PIC18F87J50 Family Silicon Errata and Data Sheet Clarification

The PIC18F87J50 family devices that you have received conform functionally to the current Device Data Sheet (DS39775B), except for the anomalies described in this document.

The following typographic corrections and clarifications are to be noted for the latest version of the device data sheet (DS39775B):

FIGURE 19-10: I²C™ SLAVE MODE TIMING (TRANSMISSION, 7-BIT ADDRESS)

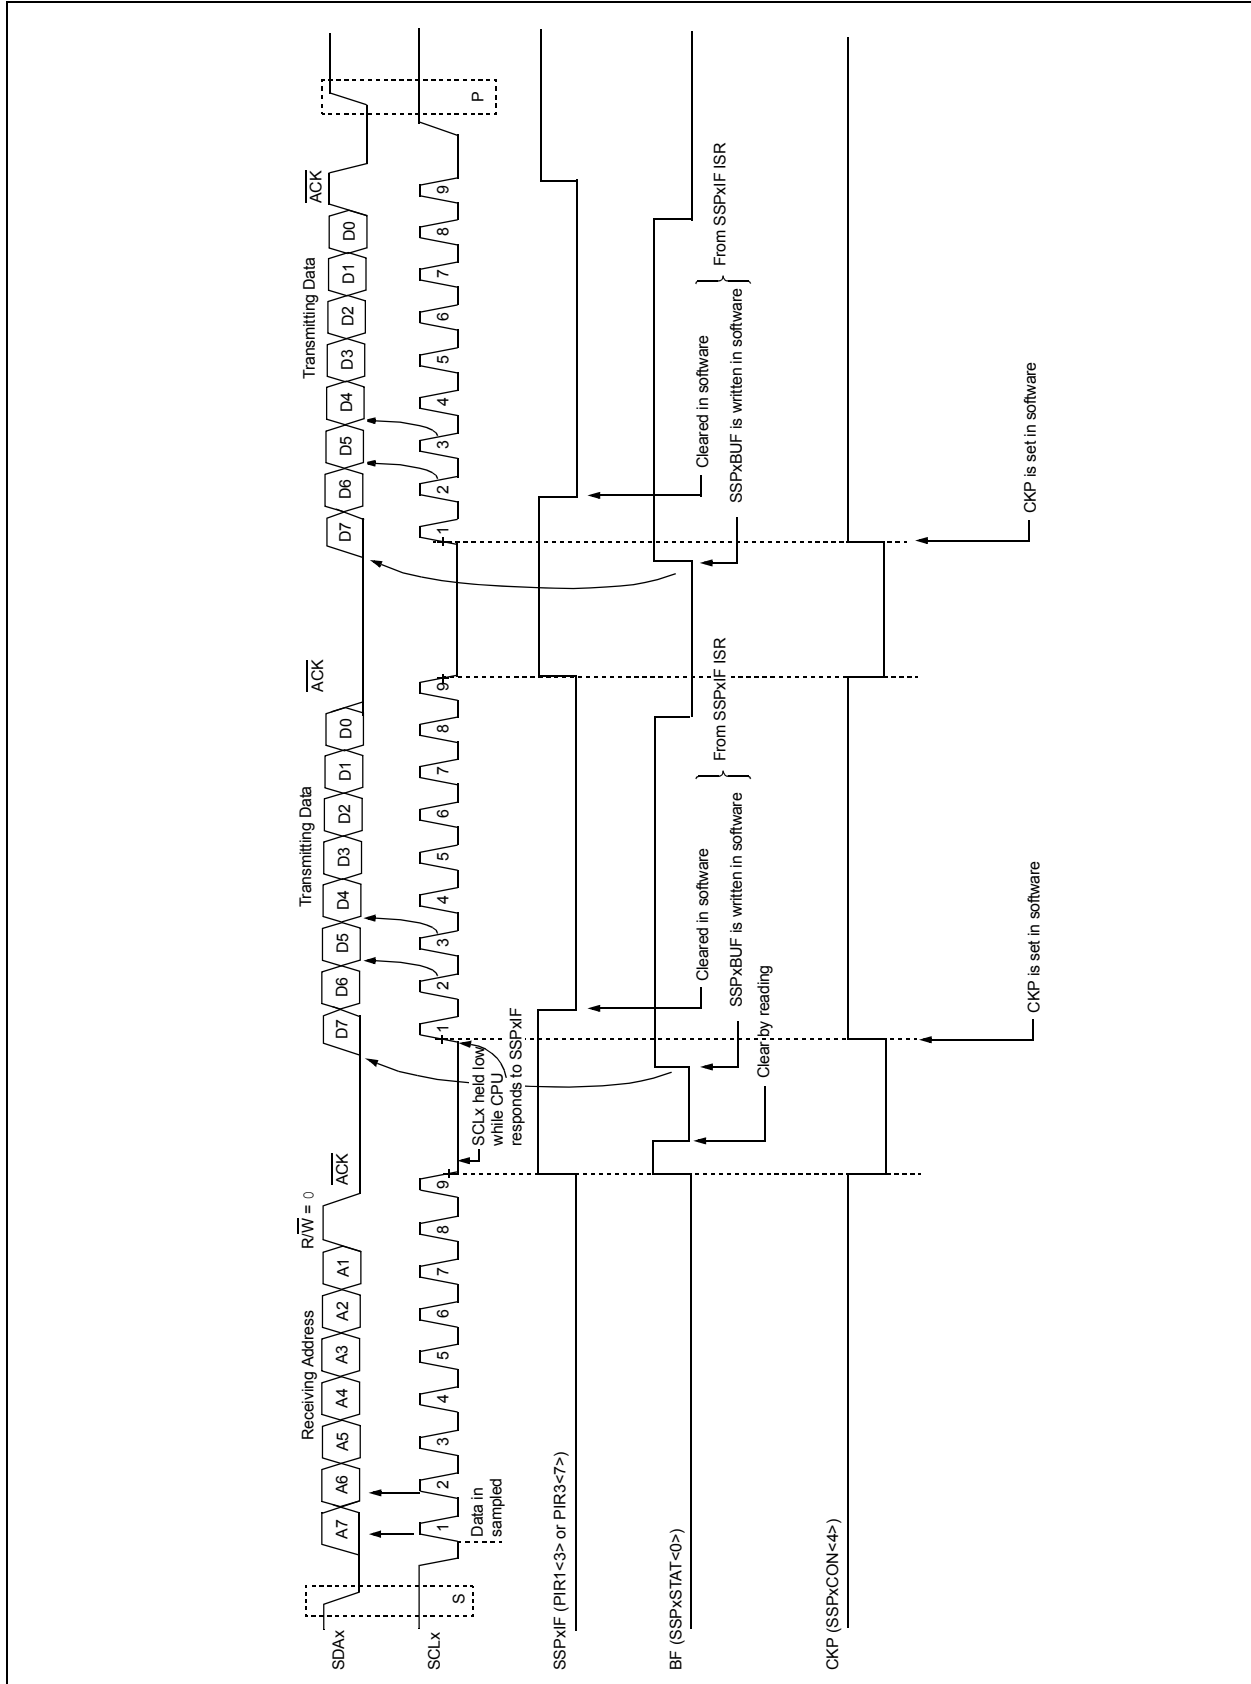
6. Module: Figure 19-10: I²C™ Slave Mode Timing (Transmission, 7-Bit Address)

On page 252, the figure is replaced with the new timing diagram provided in Figure 19-10.

FIGURE 19-24: I²C™ MASTER MODE WAVEFORM (RECEPTION, 7-BIT ADDRESS)

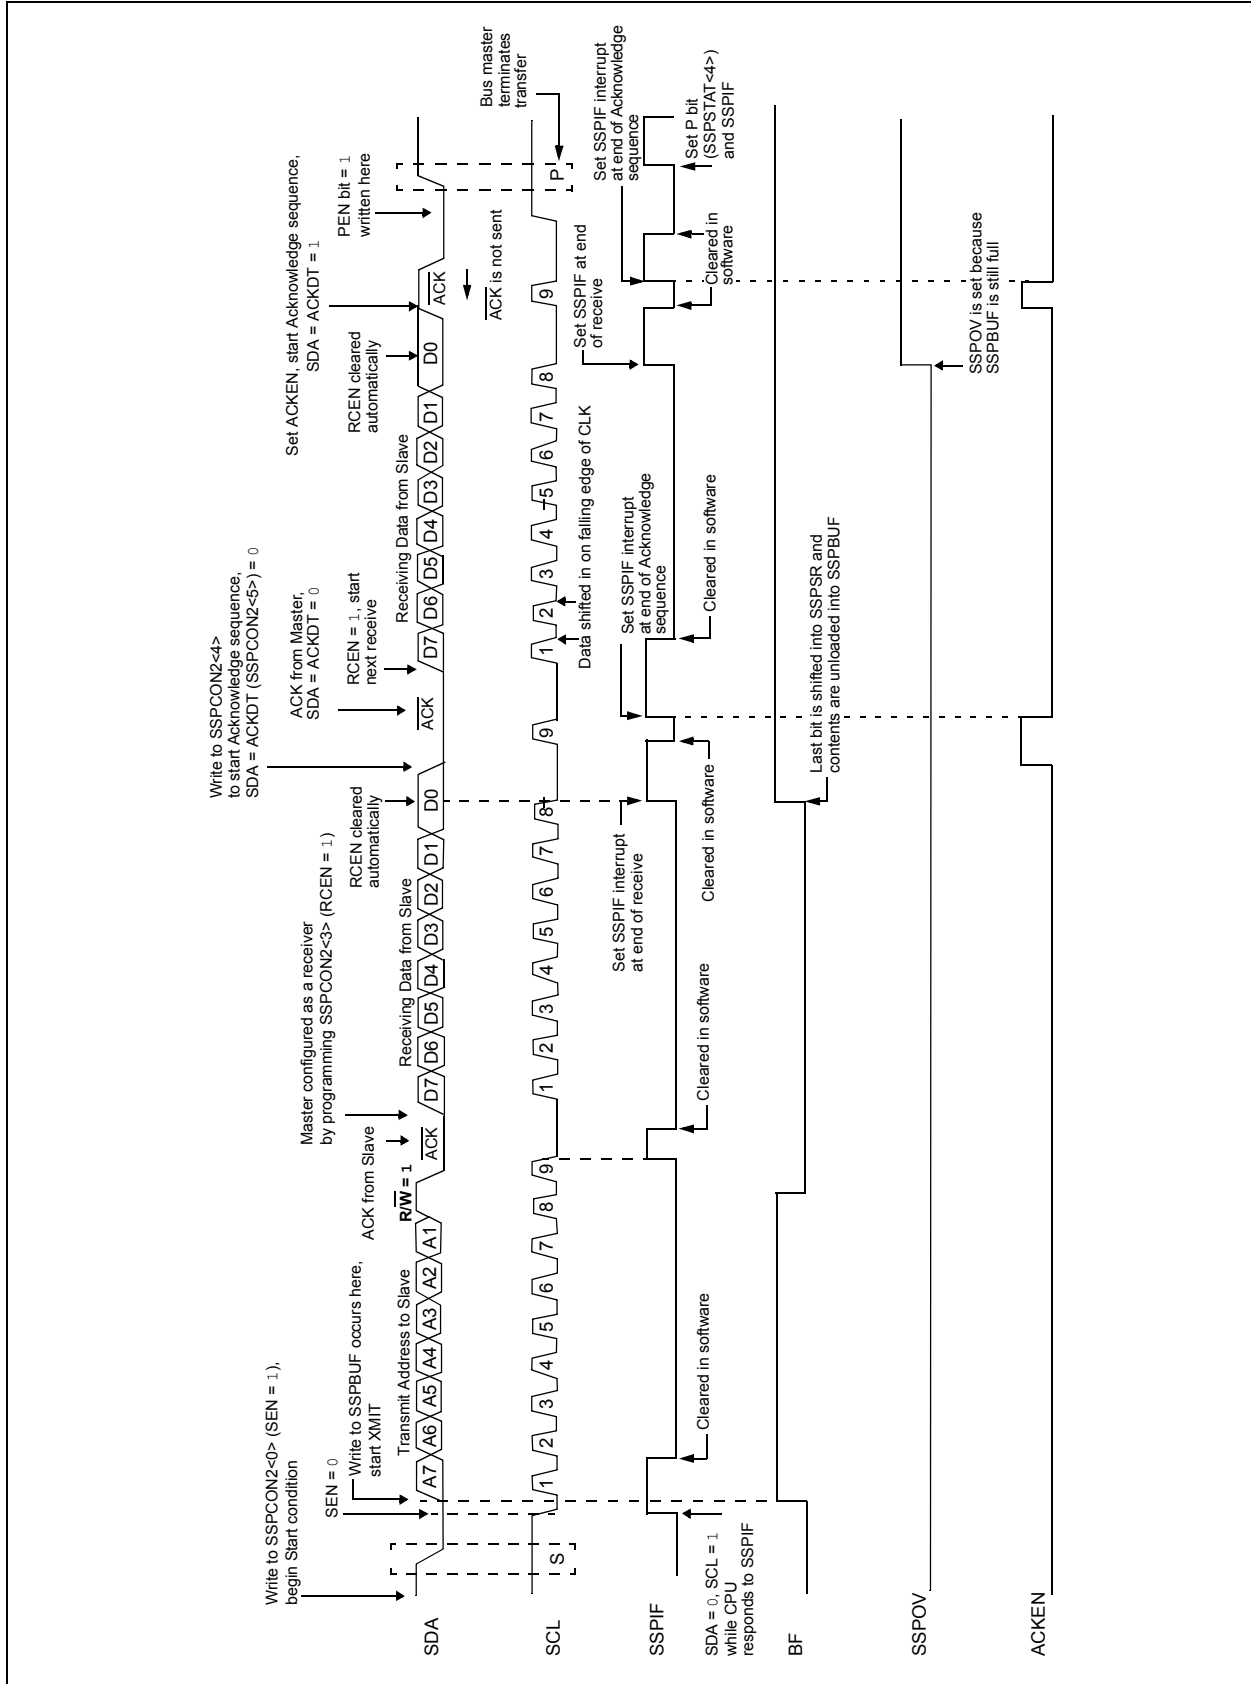
7. Module: **Figure 19-24: I²C™ Master Mode Waveform (Reception, 7-Bit Address)**

On page 269, the condition, R/\overline{W} , when the Acknowledge signal (ACK) is received from the slave, after transmitting the address to the slave, is changed to '1'.

The changed value is indicated in bold text in Figure 19-24.
